ADDITIONAL S75W AMENDMENTS 26.09.18:

**PROPOSED MIXED USE DEVELOPMENT**

47-50 THE ESPLANADE ETTALONG BEACH

AMENDED SUBMISSION			
Job no.	Drawing no.	Rev.	
J15304S2	DA 101	F

Drawing Title  
NORTH & SOUTH  
ELEVATIONS

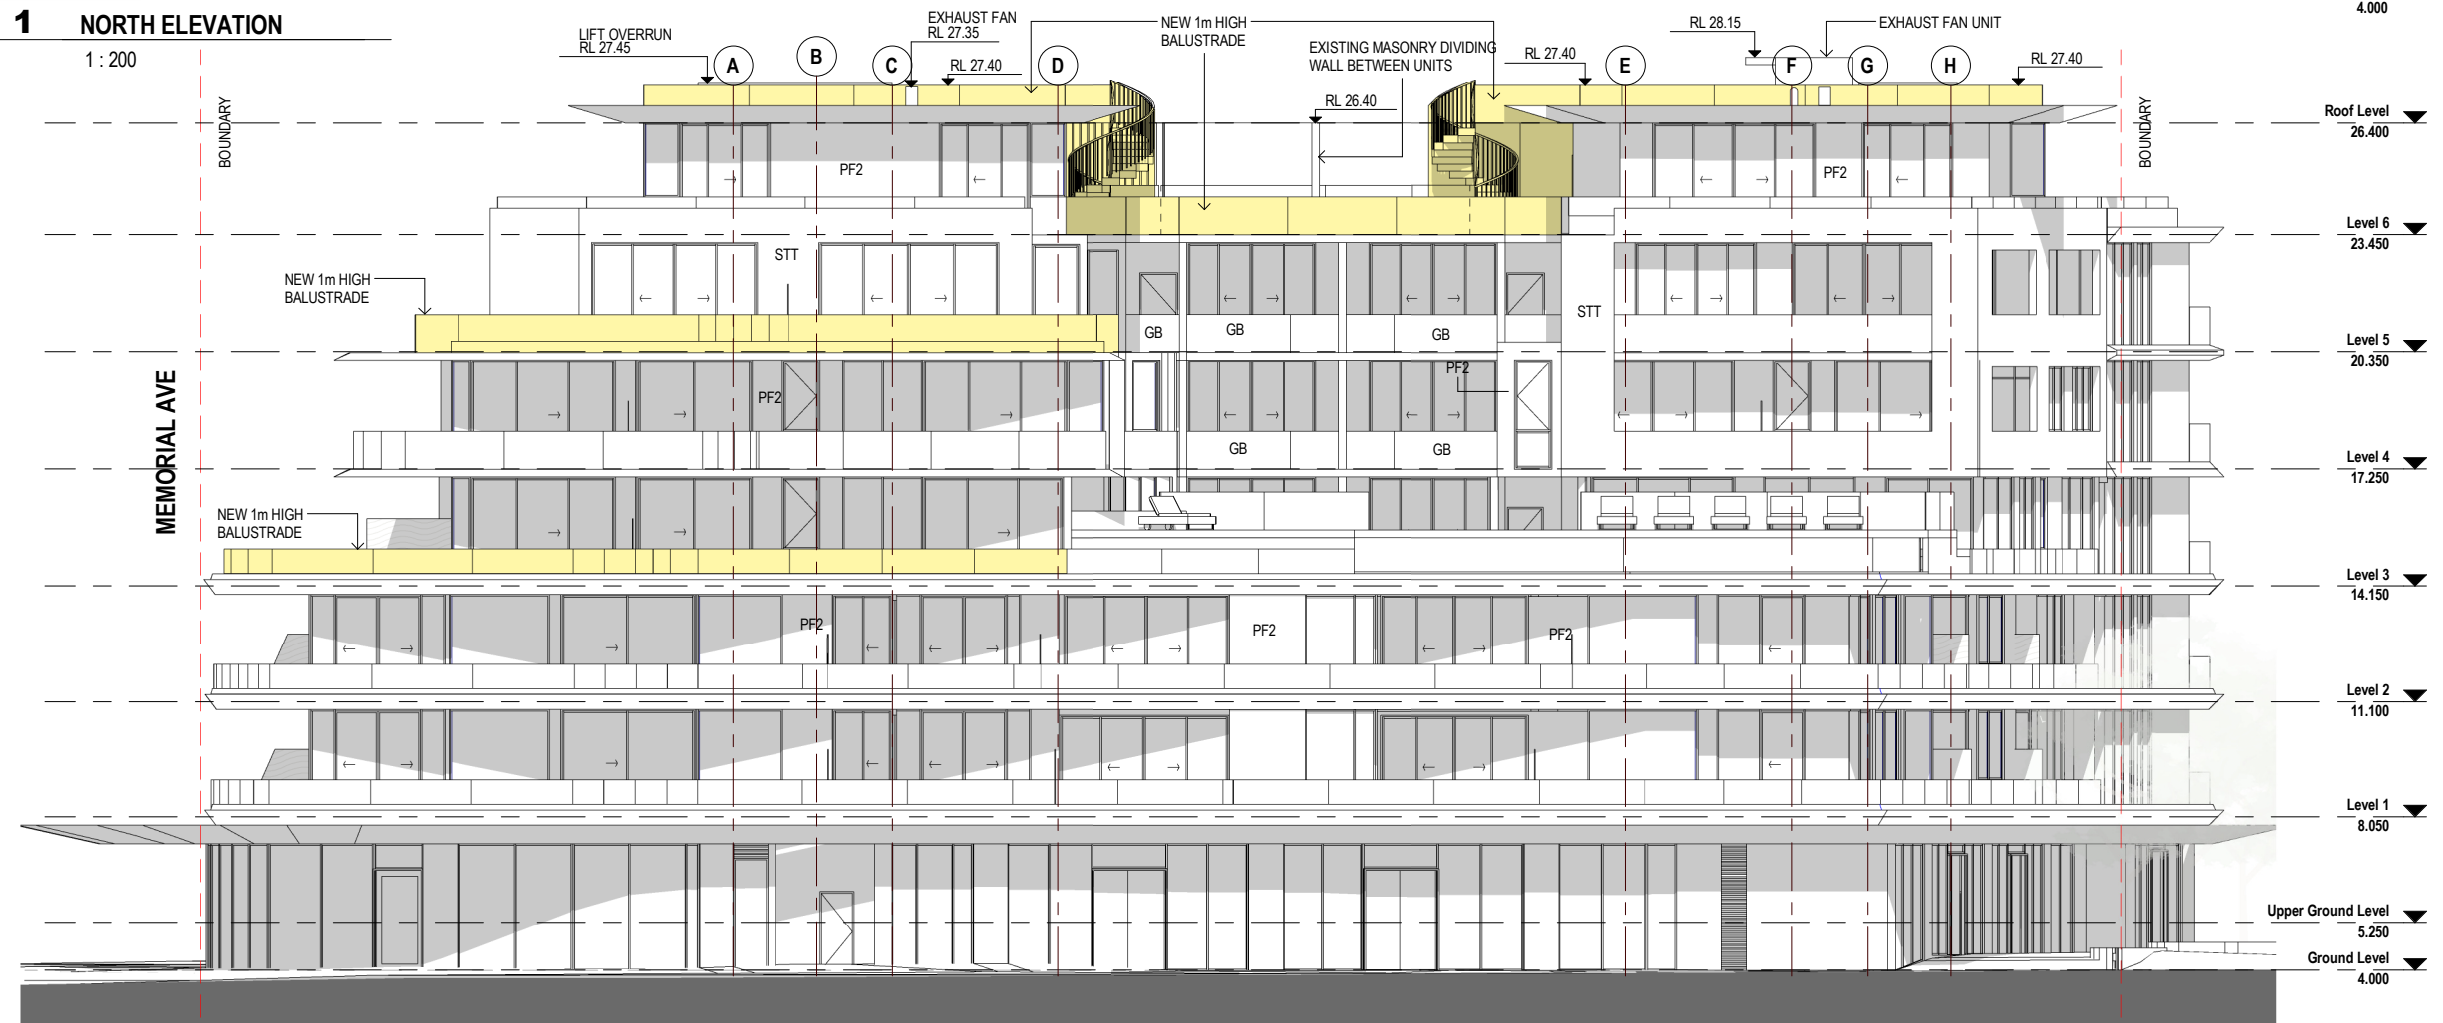
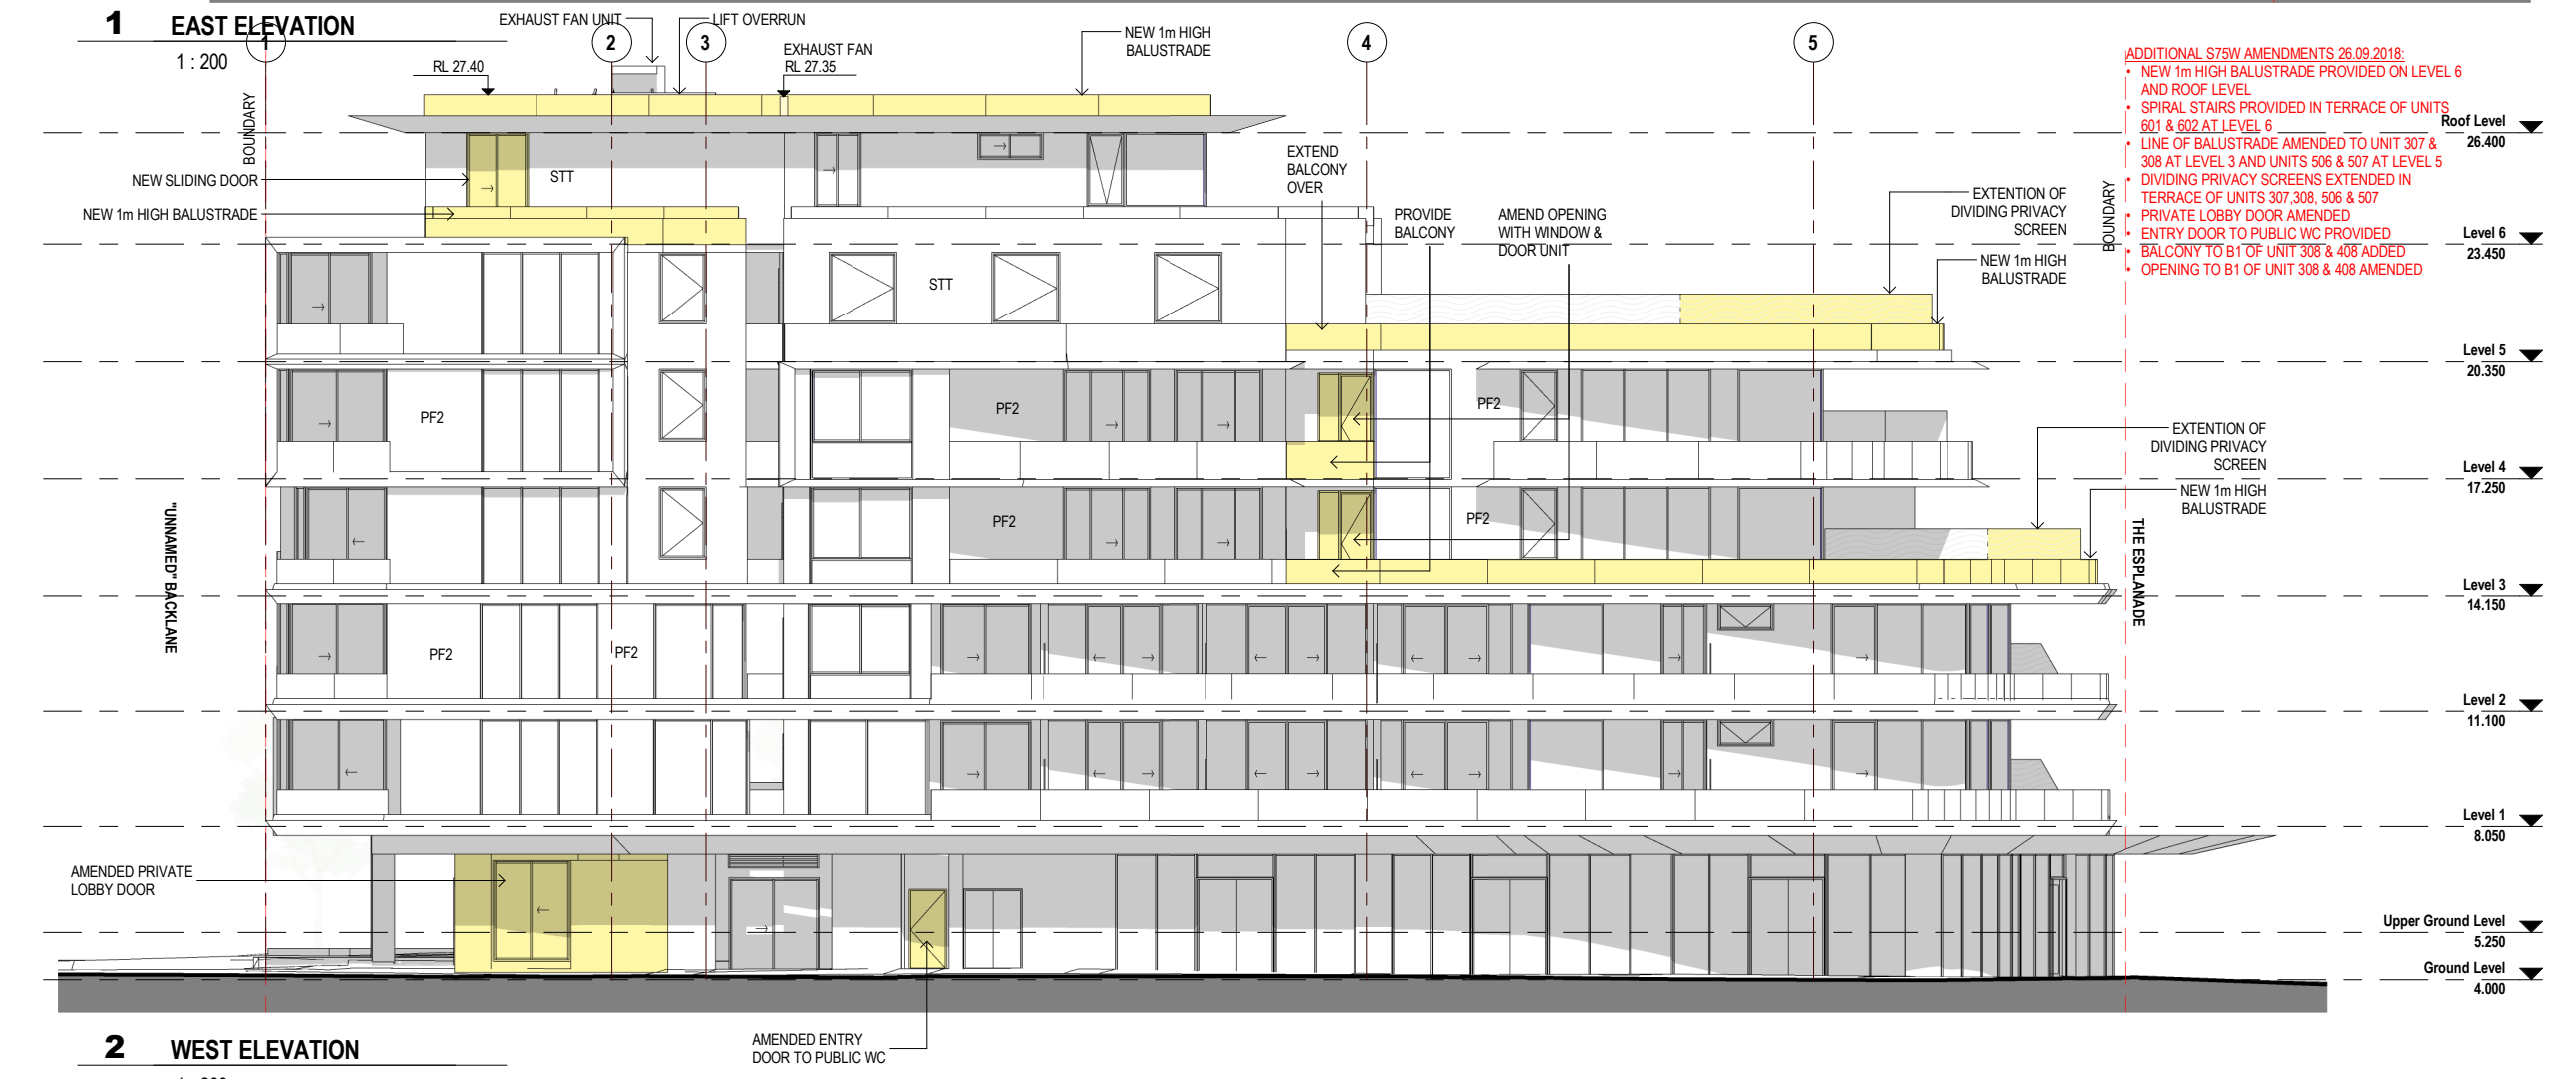
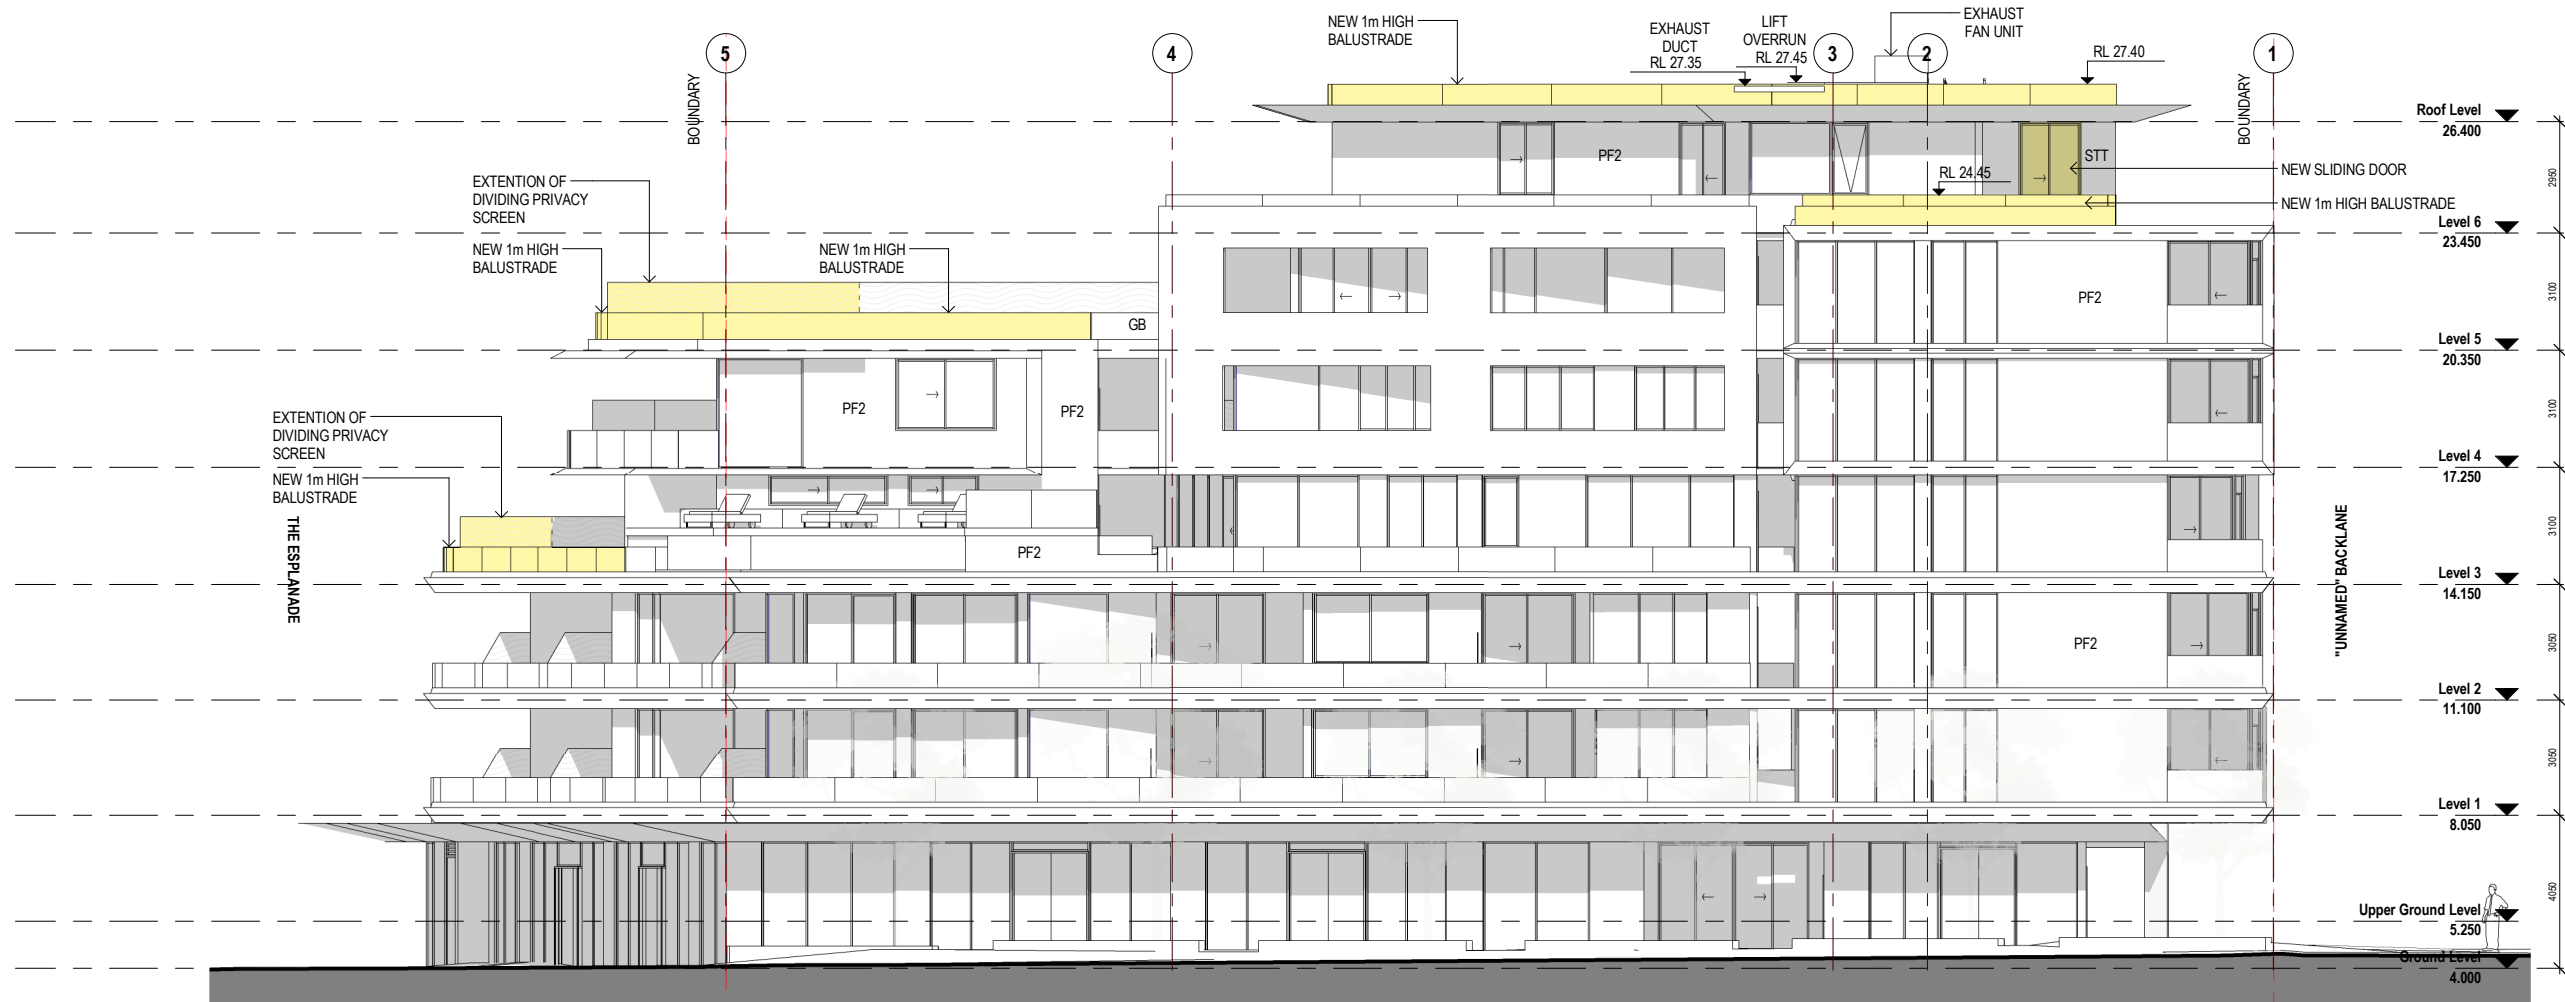
Rev.	Date	Description
1	26.09.2018	ADDITIONAL S75W AMENDMENTS 26.09.2018:
2	26.09.2018	NEW 1m HIGH BALUSTRADE PROVIDED ON LEVEL 6 AND ROOF LEVEL
3	26.09.2018	SPIRAL STAIRS PROVIDED IN TERRACE OF UNITS 601 & 602 AT LEVEL 6
4	26.09.2018	LINE OF BALUSTRADE TO UNIT 307 & 308 AMENDED AT LEVEL 3
5	26.09.2018	LINE OF BALUSTRADE TO UNIT 506 & 507 AMENDED AT LEVEL 5

1 SECTION A  
1:200

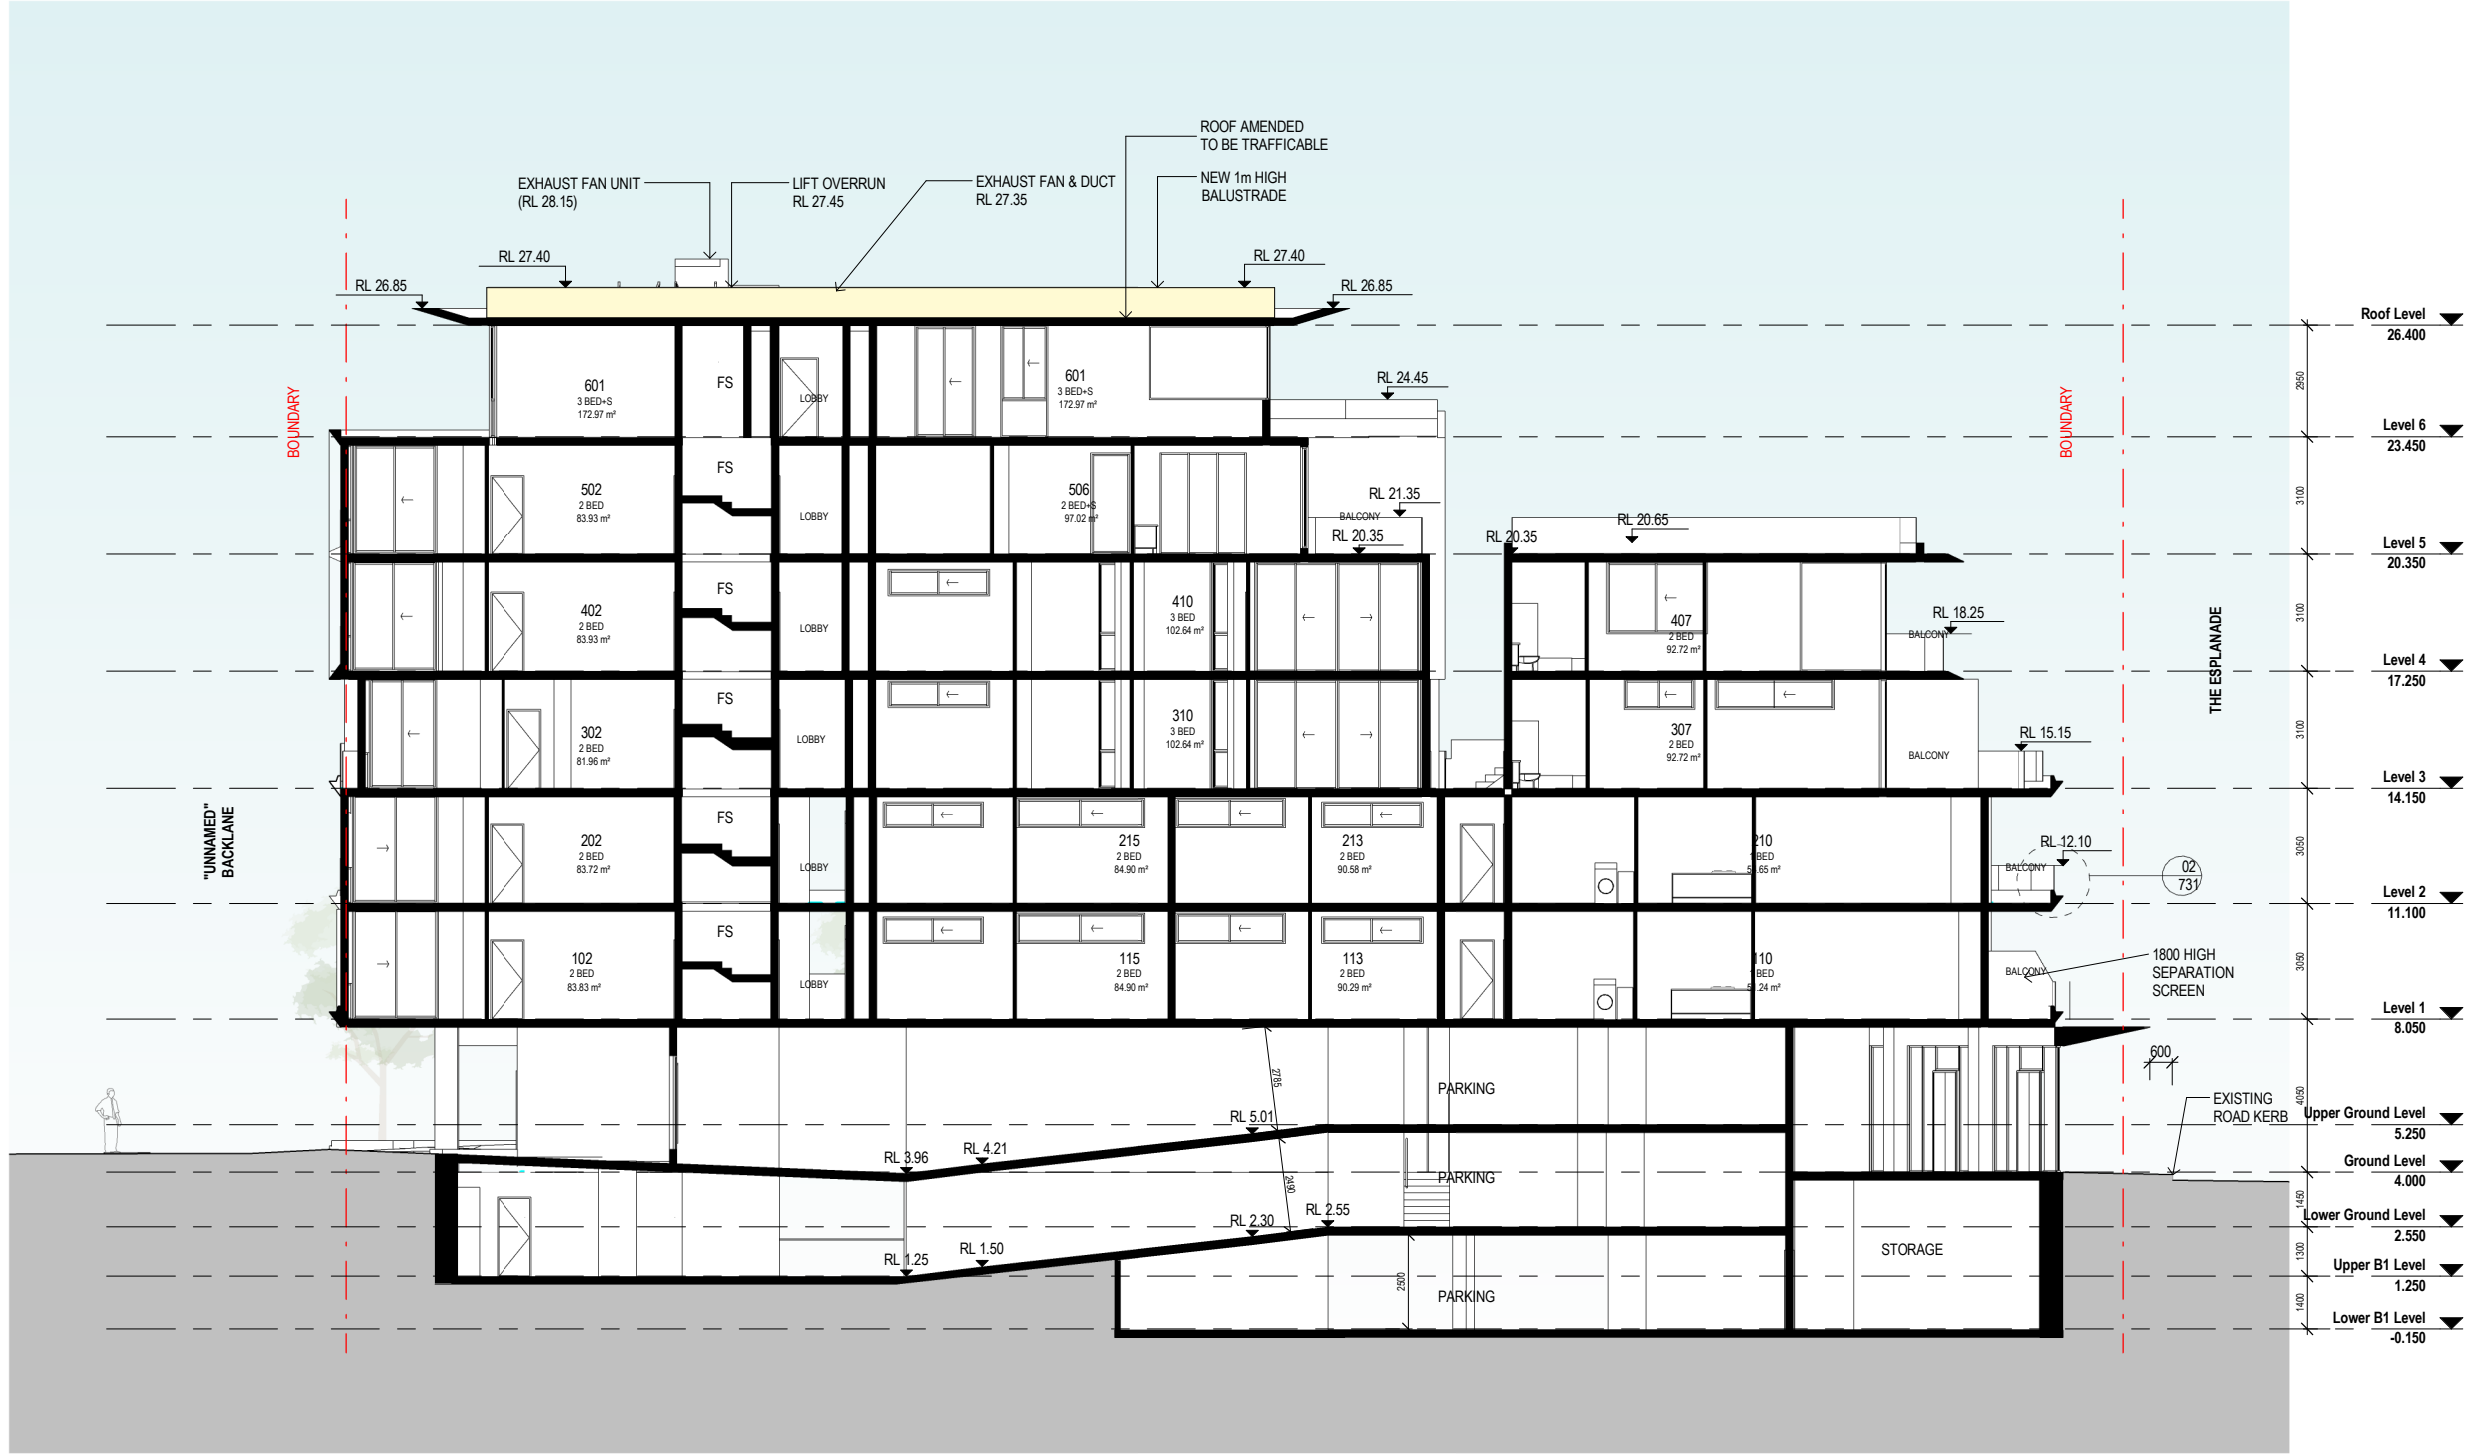
- NEW 1m HIGH BALUSTRADE PROVIDED ON ROOF LEVEL
- ROOF AMENDED TO BE TRAFFICABLE
